August 3, 1984

HOPE CREEK GENERATING STATION  
DOCKET NO. 50-354  
DRAFT SAFETY EVALUATION REPORT  
OPEN ITEM STATUS

In addition, enclosed for your review and approval (see Attachment 4) are the resolutions to the Draft SER open items, FSAR question responses and structural geotechnical audit item responses, listed in Attachment 3.

FIGURE A-13-7  
RESONANCE SPECTRA COMPARISON.

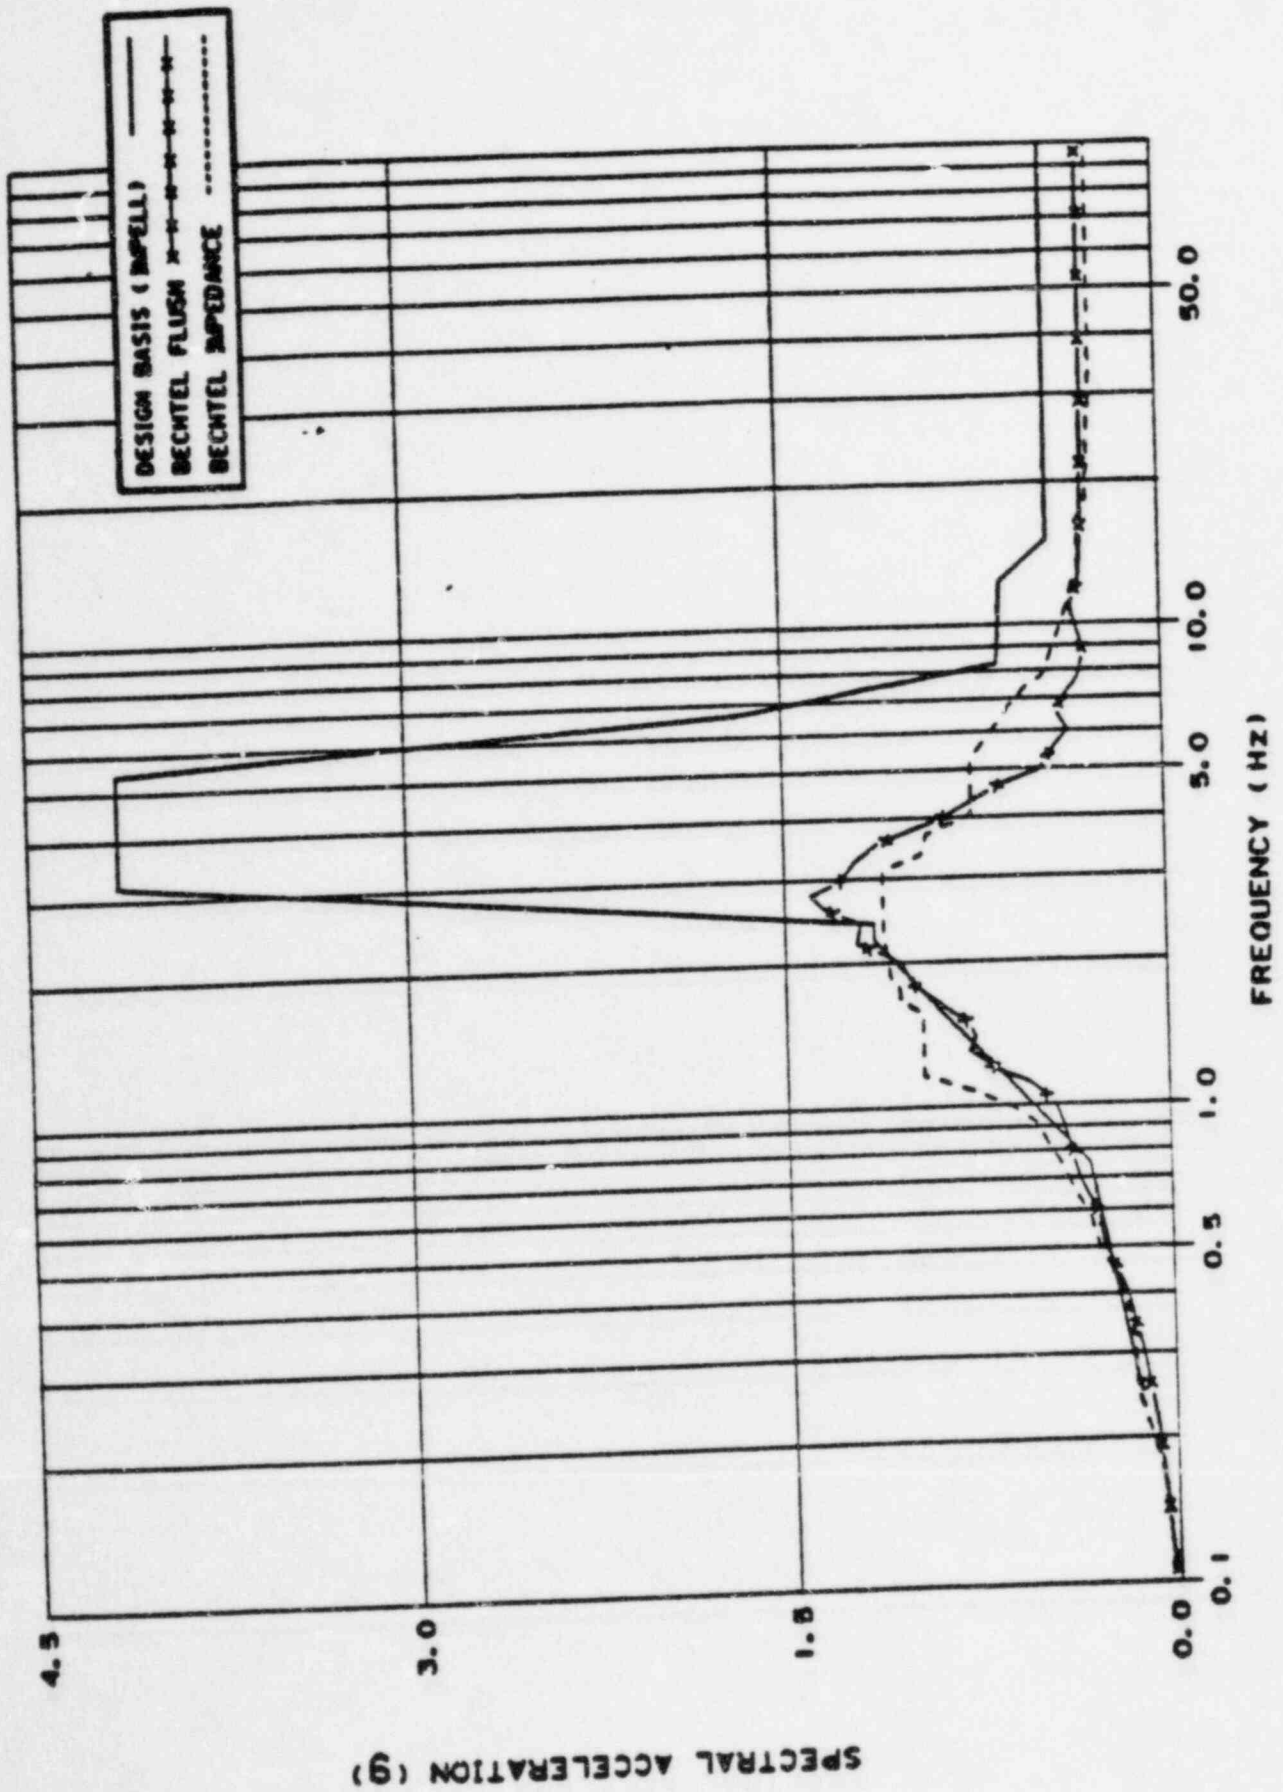
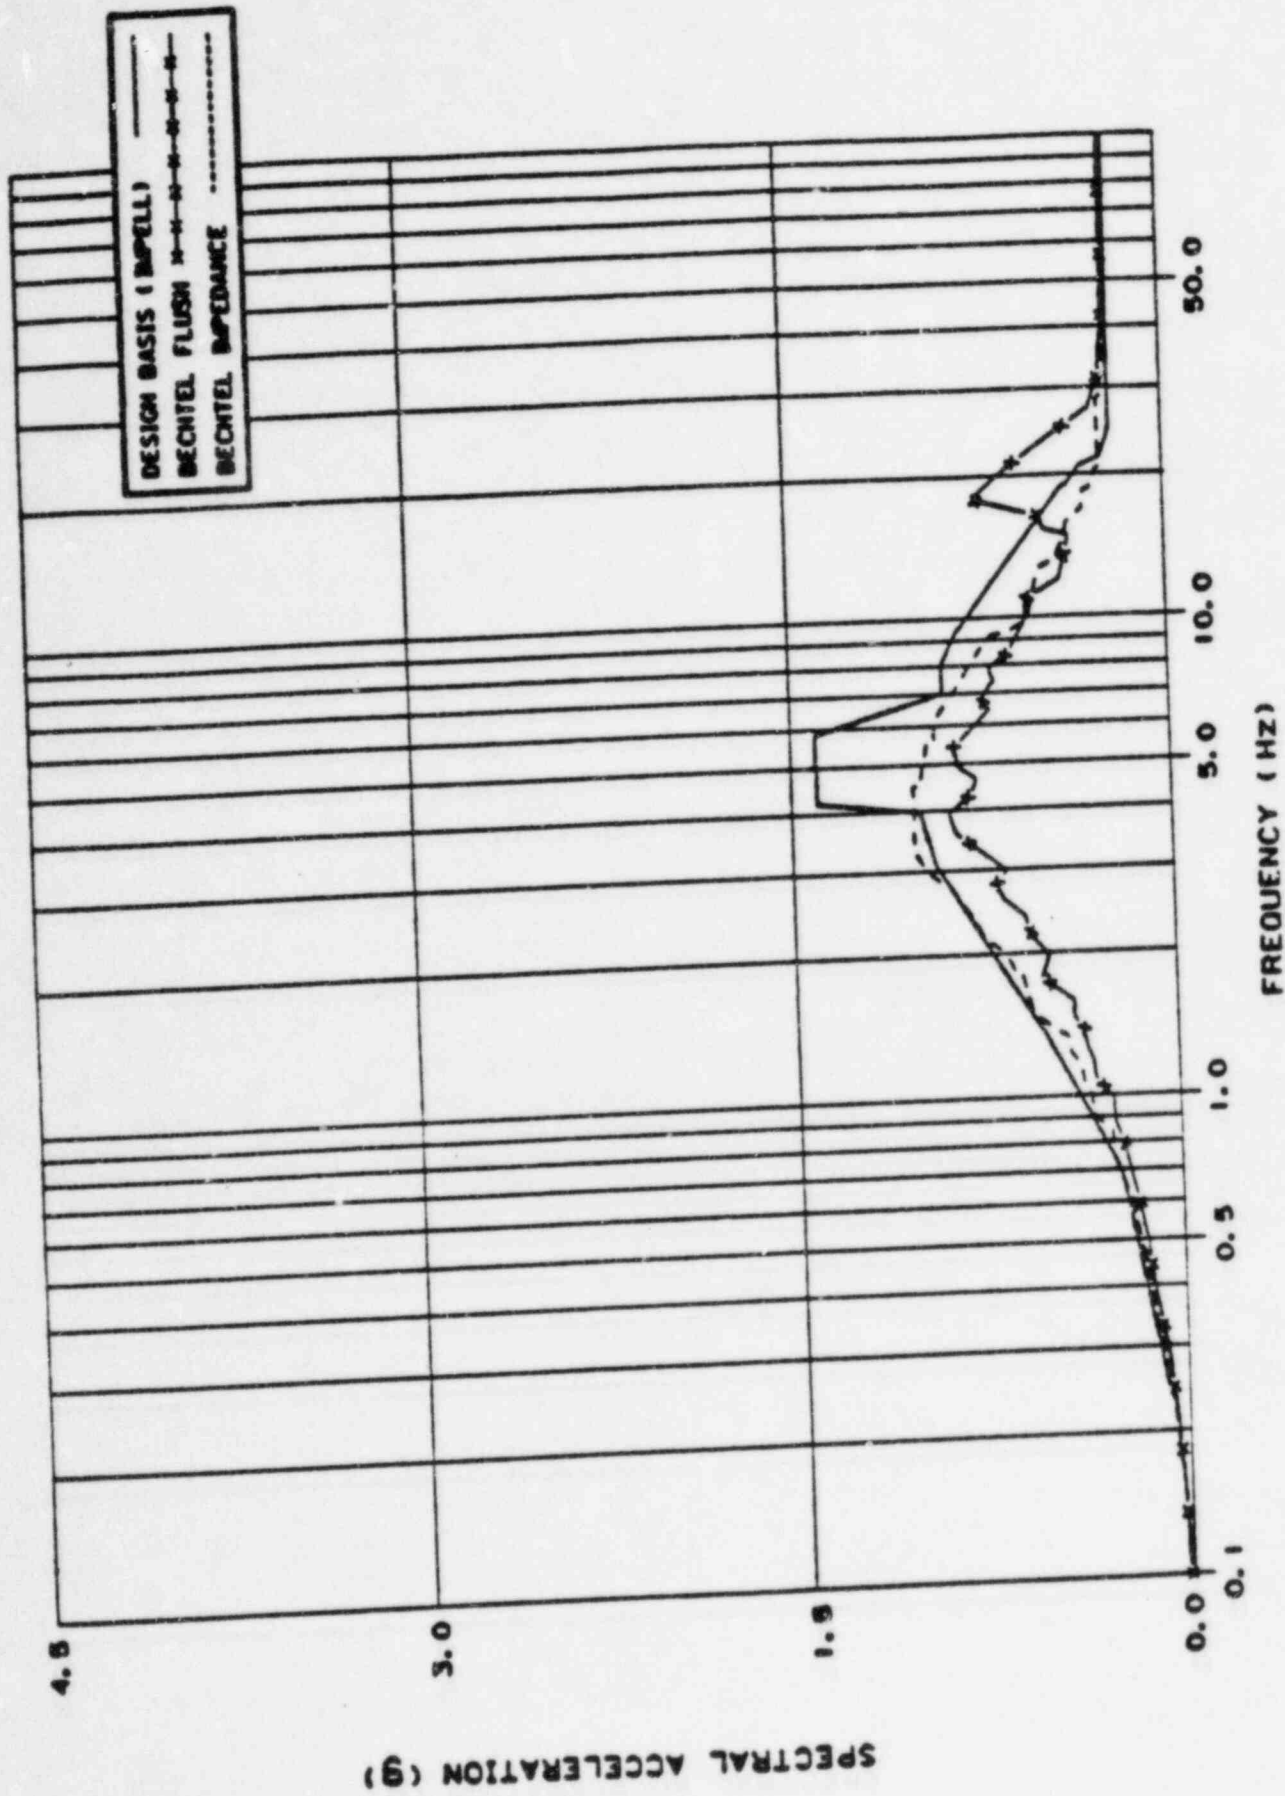
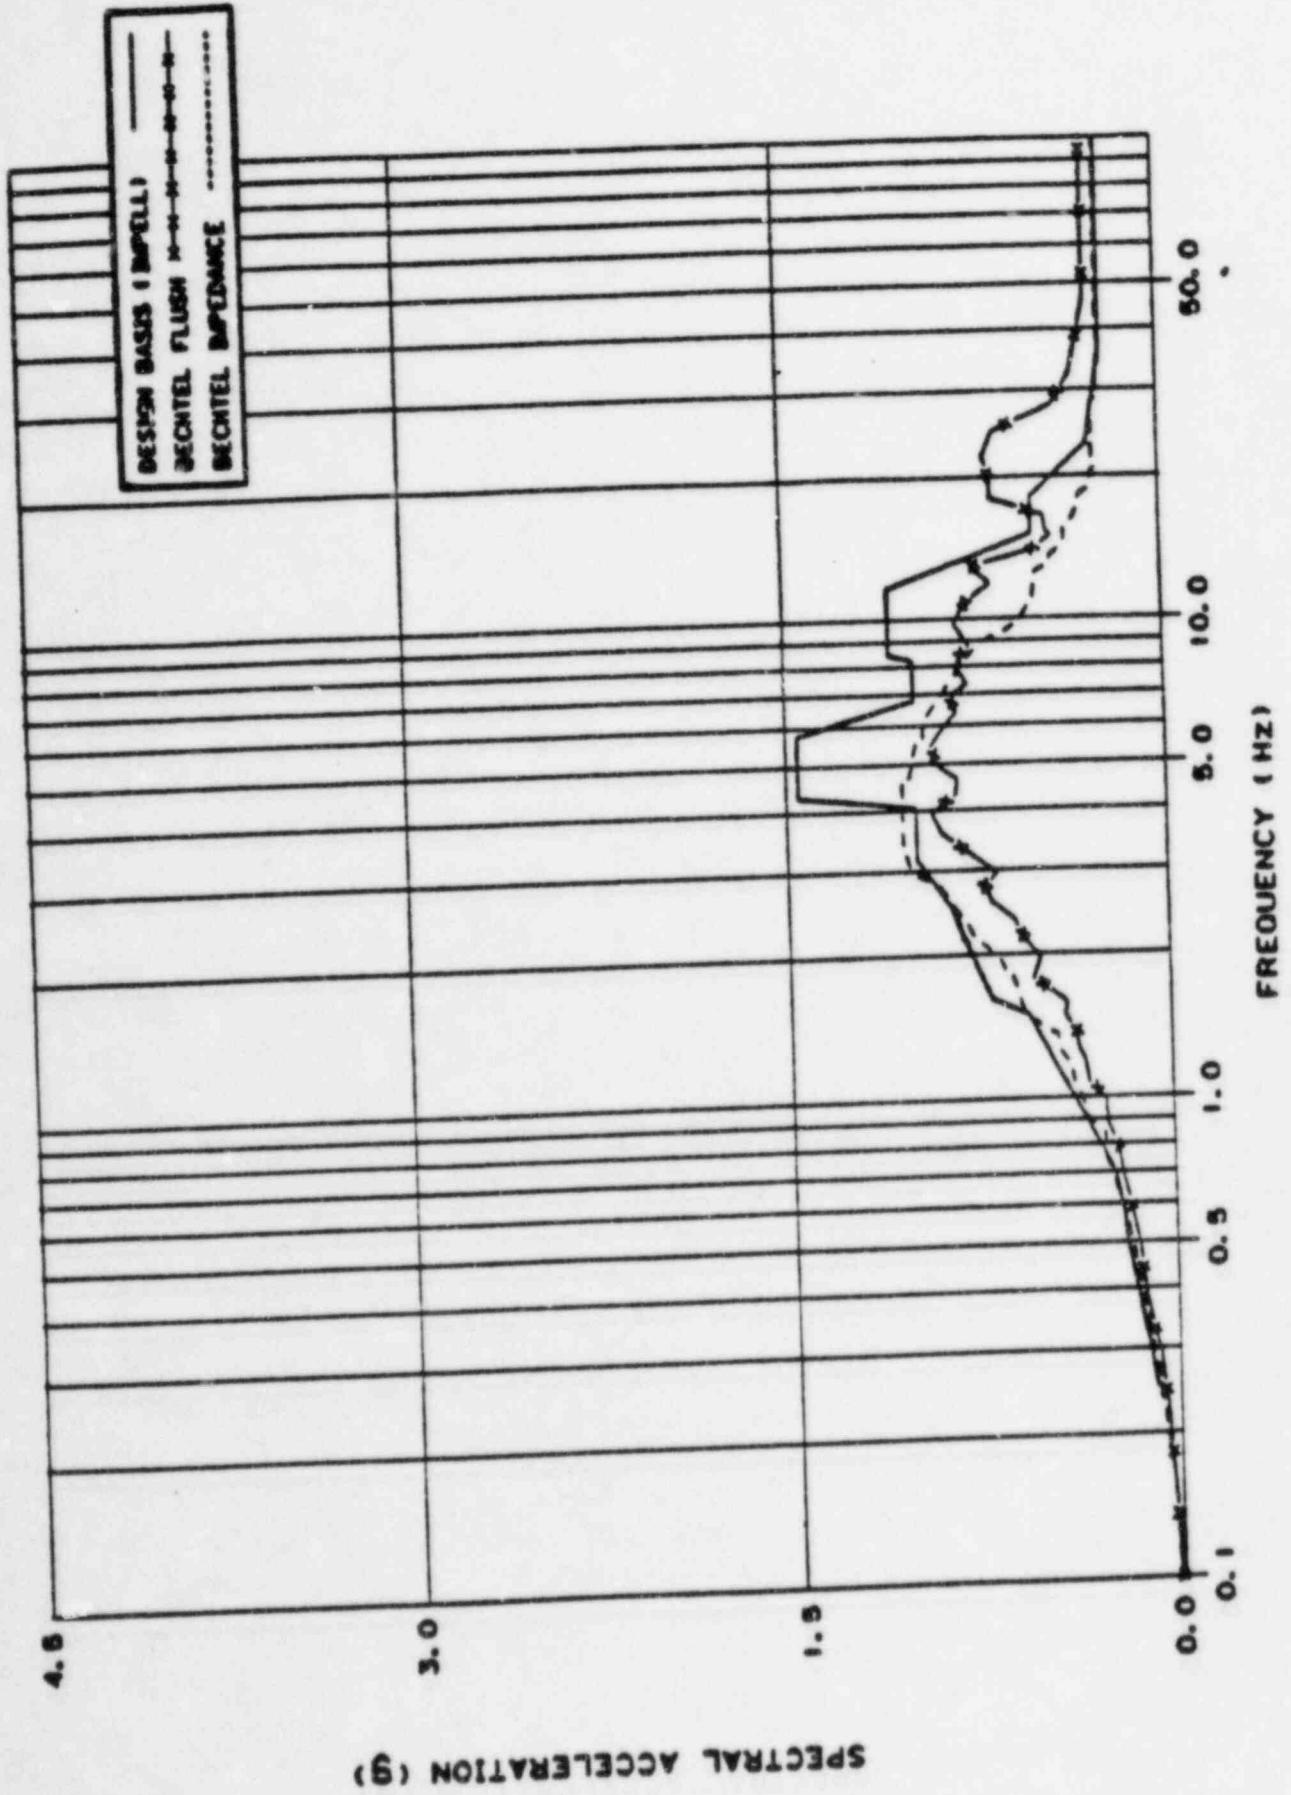
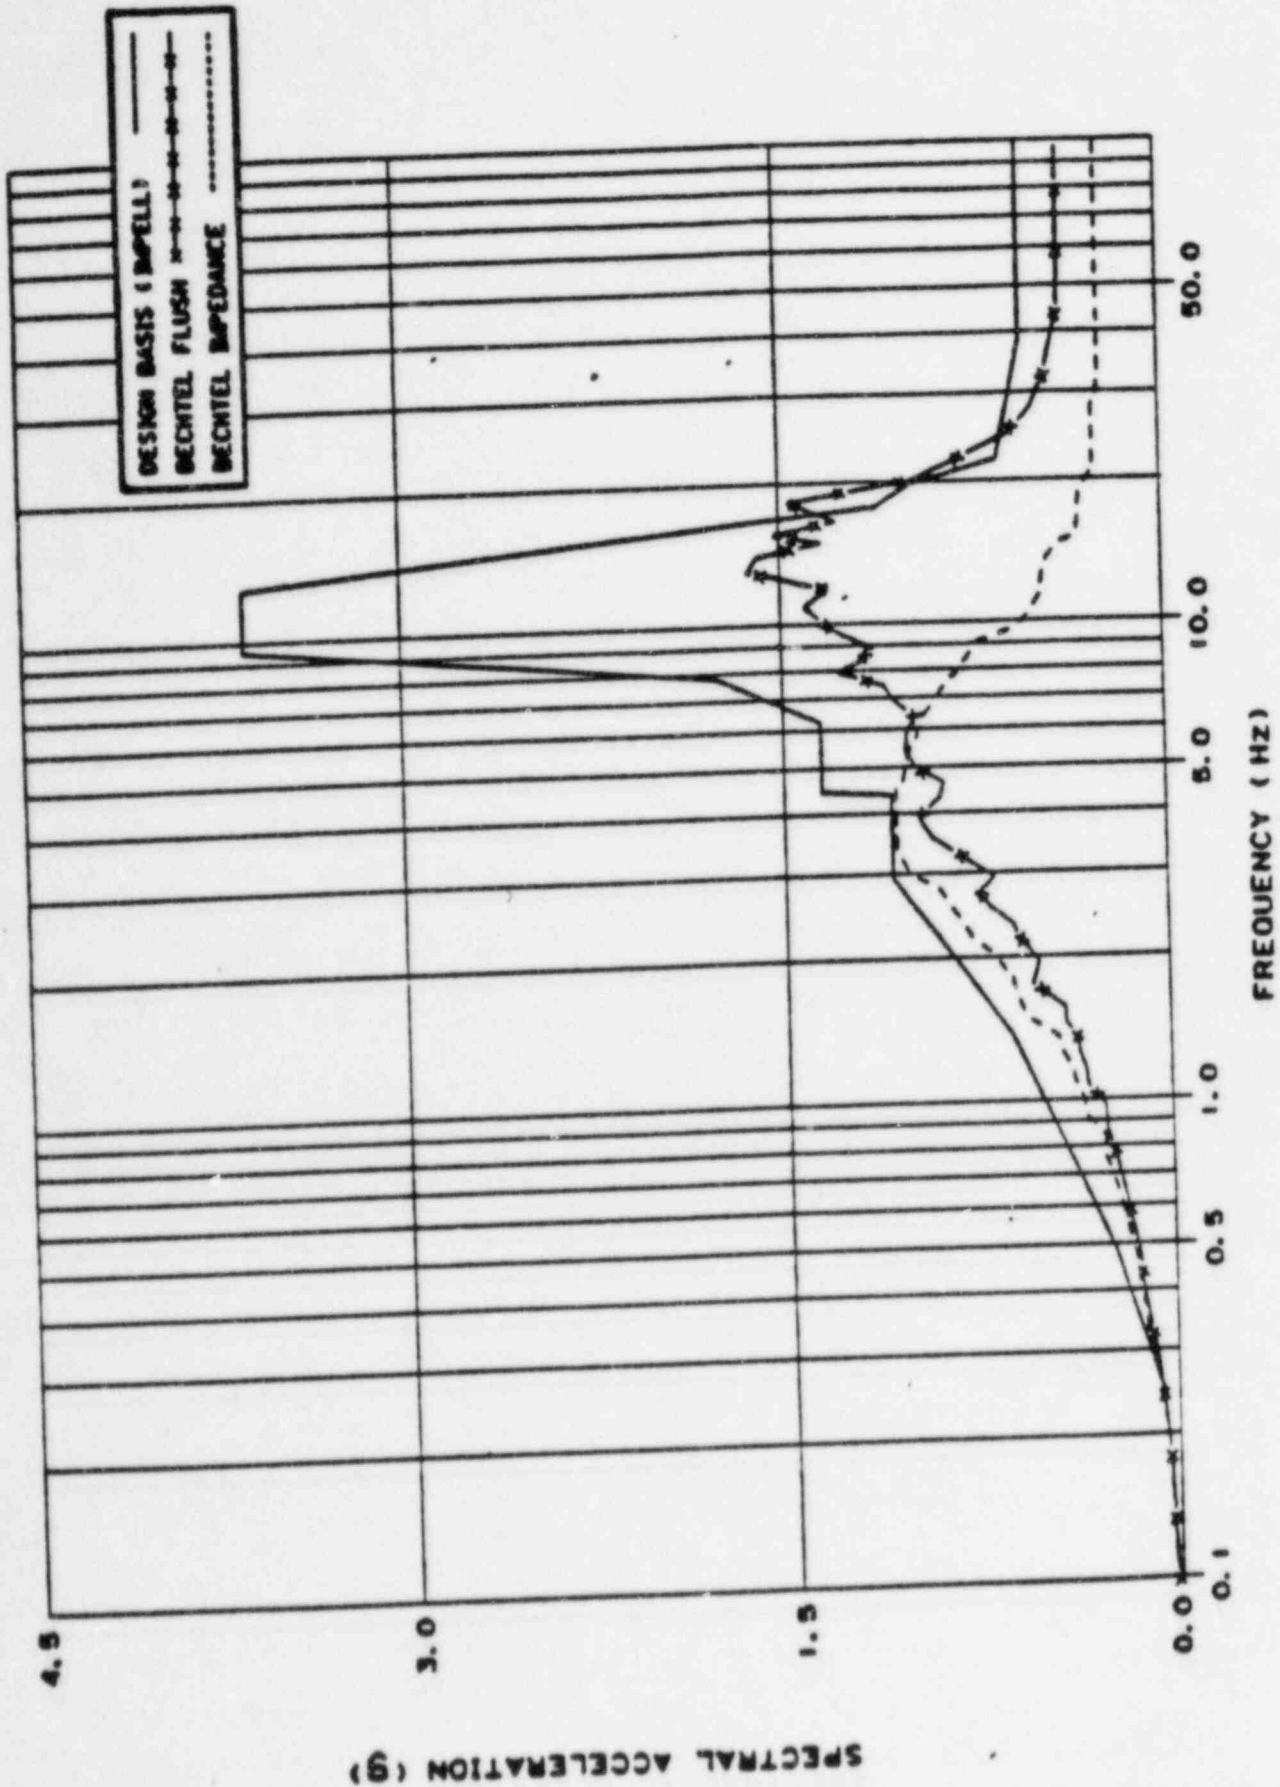
Question: Provide comparison of Bechtel Independent Verification Results with the Design Basis Results.

Figures A-13-2 to A-13-37 show the comparison of the response spectra (2% damping) obtained from the above three seismic soil-structure interaction analyses. Discussions of these comparisons are as follows:

Bechtel's independent soil-structure interaction analyses are performed using the computer code FLUSH. The results of independent finite element analyses are in reasonable agreement with those of the design basis analyses. As can be seen from Figures A-13-2 through A-13-37, the horizontal response spectra obtained from the independent finite element analyses are generally enveloped by those obtained from the design basis analyses except for the frequency range lower than 2 Hz. The vertical response spectra showed some exceedances at the frequency range of 18 Hz. These exceedances are listed in Table A-13-1.

The peak spectral accelerations obtained from the impedance approach analyses are generally lower than those obtained from the design basis analyses. However, these response spectra are not completely enveloped by those obtained from the design basis analysis, especially in the frequency range between 1.0 and 3.5 Hz. Also, there are some local exceedances in the higher frequency range, as shown in Figures A-13-2 through A-13-37.
